RIVERBEND APARTMENTS PHASE 2
CLASS III SITE PLAN REVIEW
2499, 2501, 2519, 2539 WALLACE RD NW, SALEM, OR 97304

RIVERBEND APARTMENTS – WRITTEN STATEMENT SITE PLAN REVIEW – CLASS 3, ADJUSTMENT – CLASS 2, ~~TREE VARIANCE,~~ ~~LOT LINE ADJUSTMENT~~

CASE/APP NUMBER: Class 3 Site Plan Review / Class 2 Adjustment Case No. SPR-ADJ21-25

A consolidated Class 3 Site Plan Review and Class 2 Adjustment application for a proposed development to include 201 apartments, an office/recreation building, pool, and parking at 2499, 2501, 2519, and 2551 Wallace Road NW (Polk County Assessor Map and Tax Lot 073W09CD / 01300 and 073W09CD / 00900, 01000, 01101, 01301).

PHASE II MASTER PLAN OVERALL SITE PLAN
SCALE: 1" = 40'
REVISED 2020.01.13

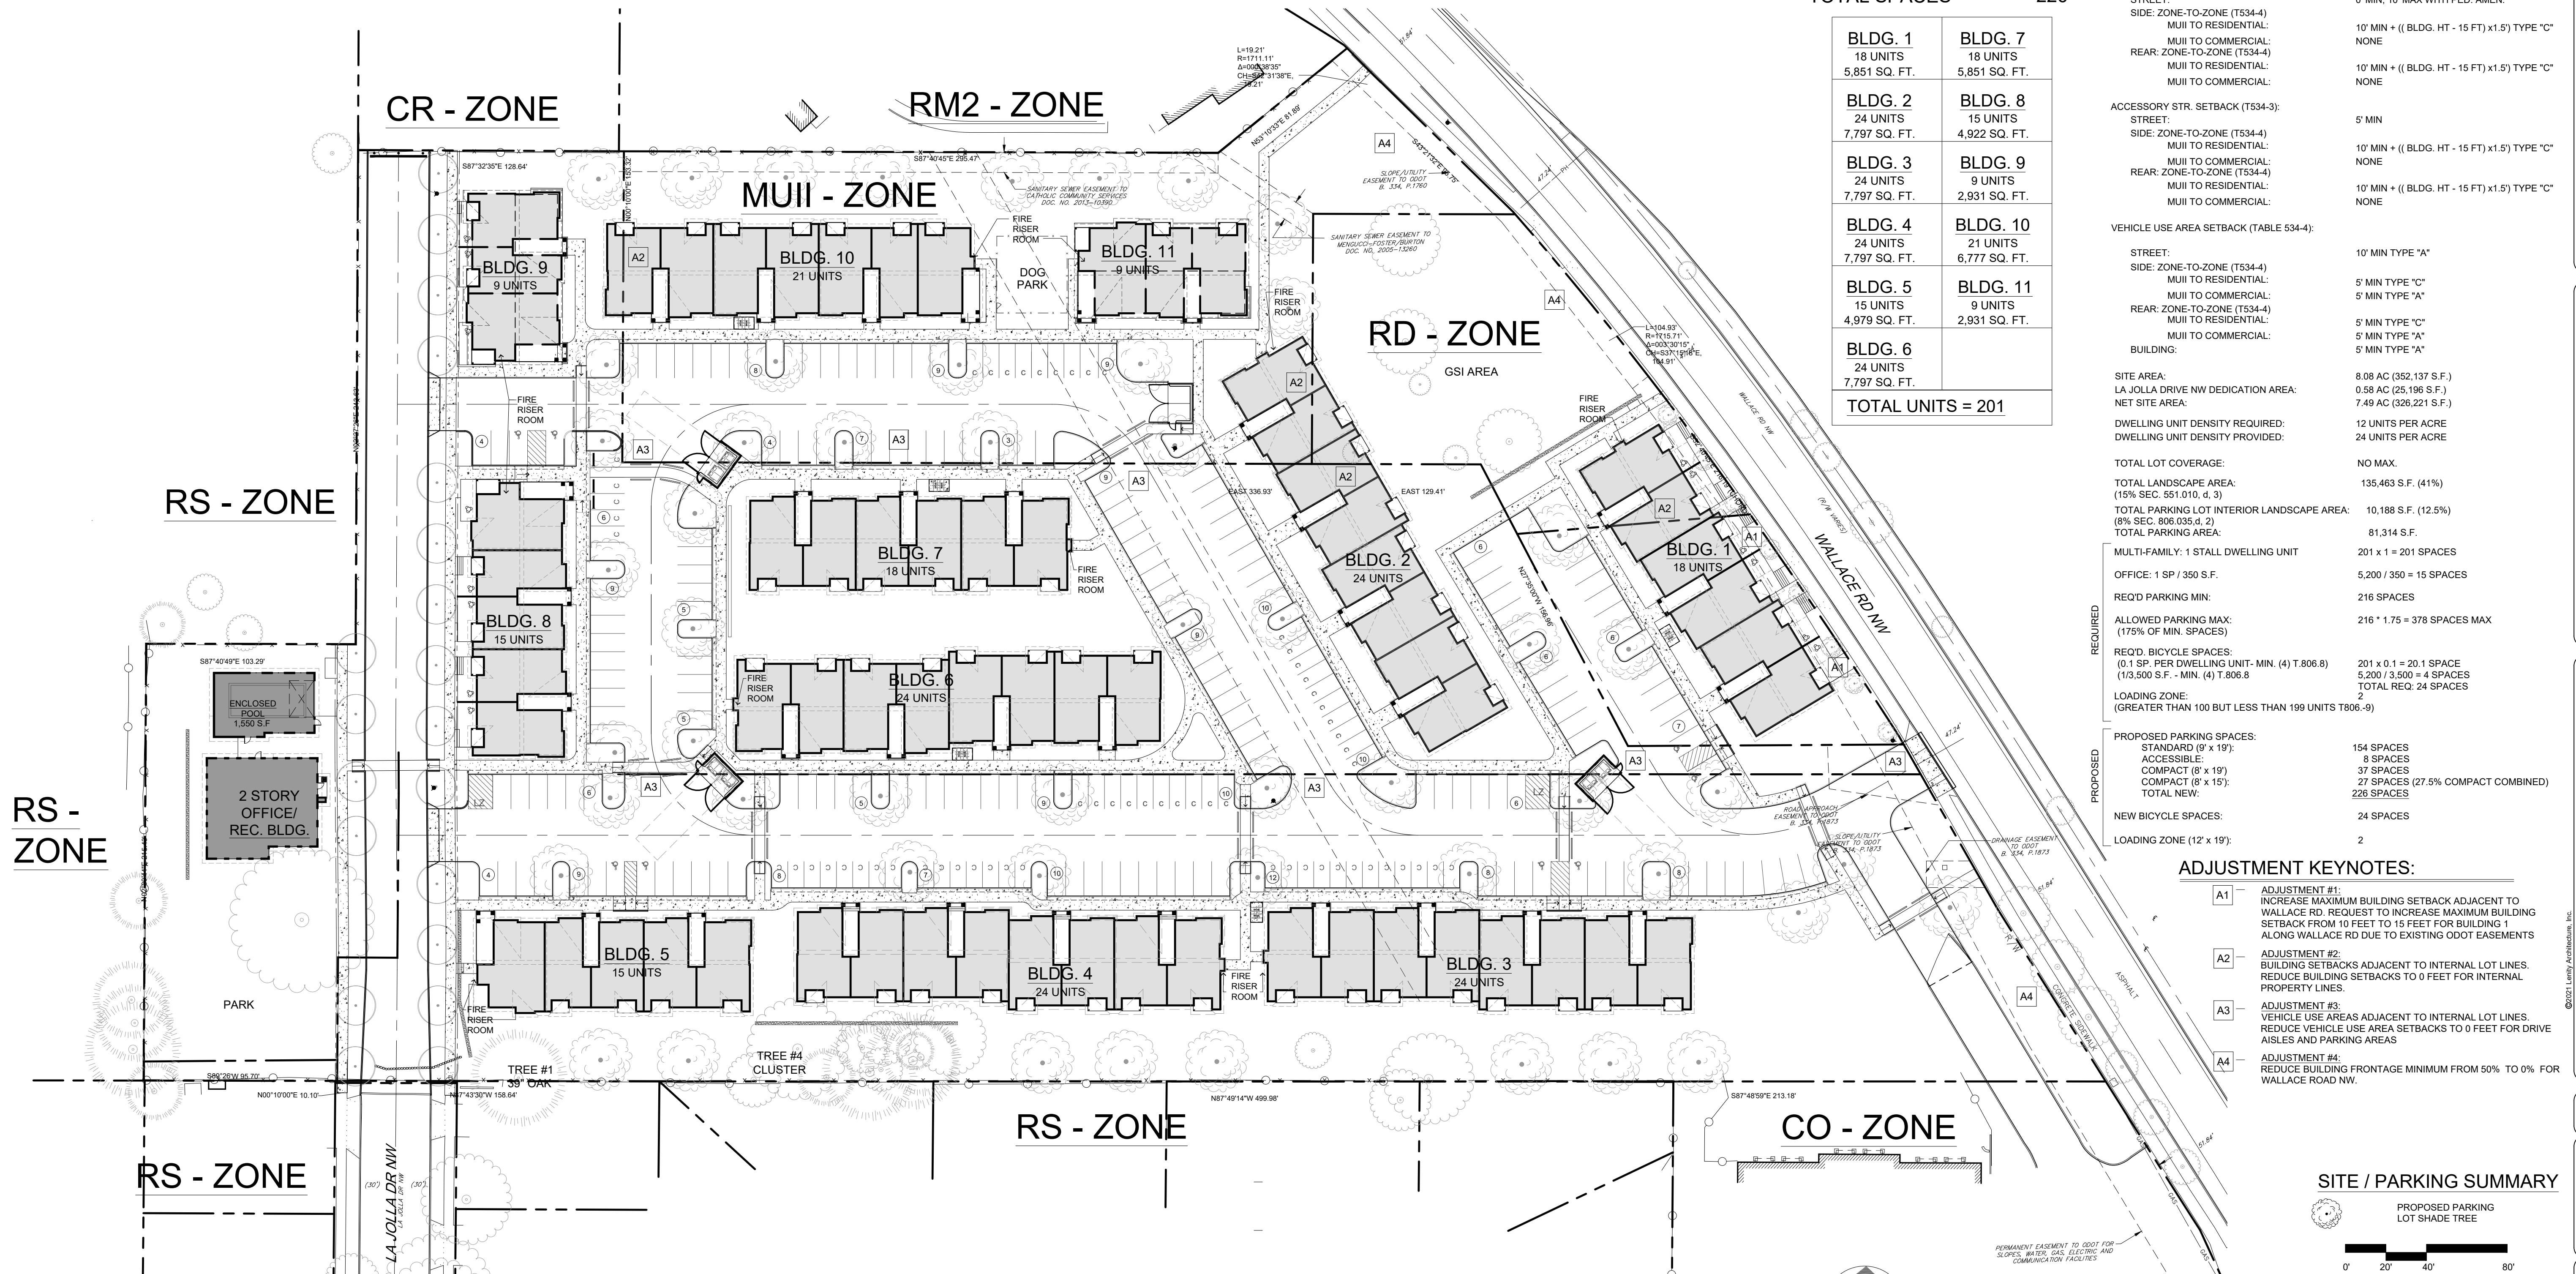
ER exits needed to Brush College Rd to ease traffic congestion on Wallace at Rush Hr. La Jolla drive another exit. Building 6 too close to Wallace, maximize setbacks to Wallace + La Jolla to leave street frontage alone at 10' + 50%. Allow room for charging electric cars! Plant maximum trees, outdoor play area? Bus stop? What is RD zone? Recreation?

Applicant Response: Thank you for taking the time to provide comments. There is through access to the development to the south that would allow emergency vehicles to either make a full loop through the site back Wallace Rd or continue south to Riverbend Rd. The MU-II zone has maximum setbacks from the frontage street, Wallace Rd. We are already asking for an increased setback due to an existing easement along Wallace Rd. Applicant will consider electric vehicle charging stations in the final design. The number of trees planted on site is above the minimum. The RD zone is the "Duplex Residential" zone. This area will be solely used for stormwater management. The closes bus stop is at the corner of Riverbend Rd and La Jolla Drive. Cherriots has commented that they do not wish to put any bus stops along Wallace Rd.

ELEVATIONS

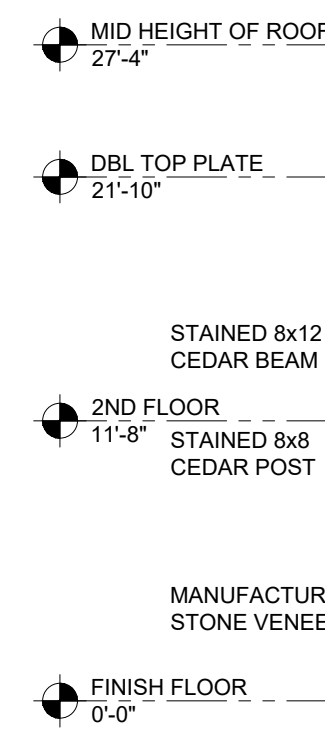
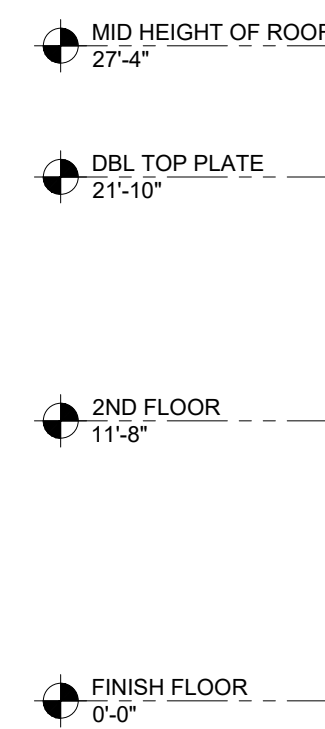
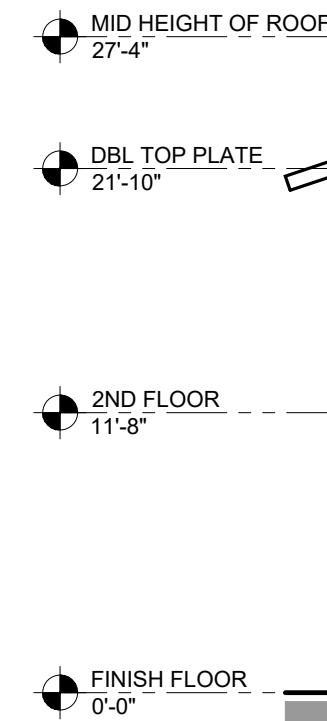
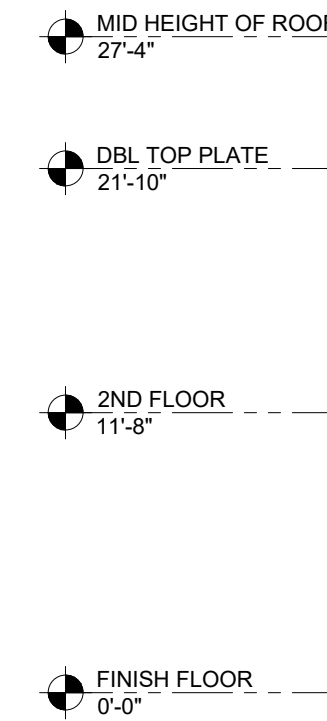
9 BUILDING ~~#8~~ REAR ELEVATION FACING LA JOLLA DR NW

Applicant Response: The design of proposed Building 1 along Wallace Road and Buildings 8 and 9, along the proposed La Jolla Dr extension, will incorporate the pedestrian-oriented standards above. A horizontal separation of 12 feet will be included between the Wallace Rd. right-of-way and dwelling unit entrance. Vertical separation ranges between 1.5 feet and 3 feet. The proposed elevations for Building 1 show a first-floor height of 10 feet.
